N7484Q

Pre-Purchase Squawk List

On-Site Pre-Buy Findings

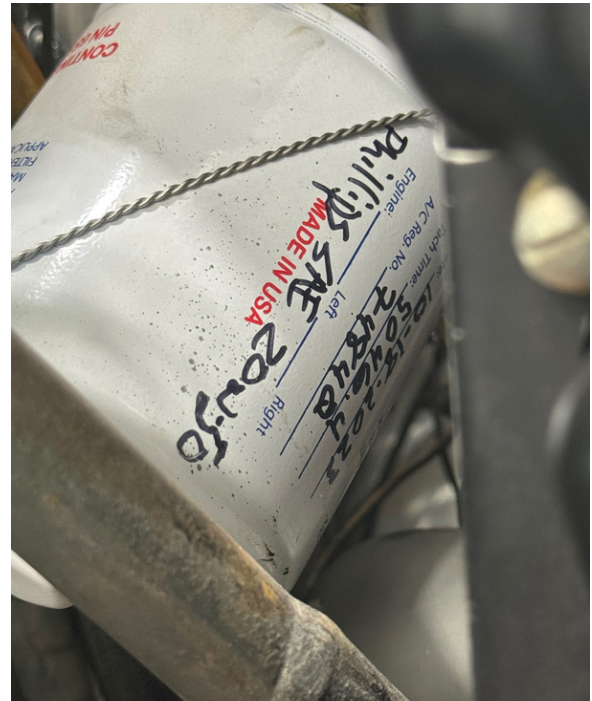
11	RH fuel seeping	C-182P MM	Remove and replace fuel sump	\$50
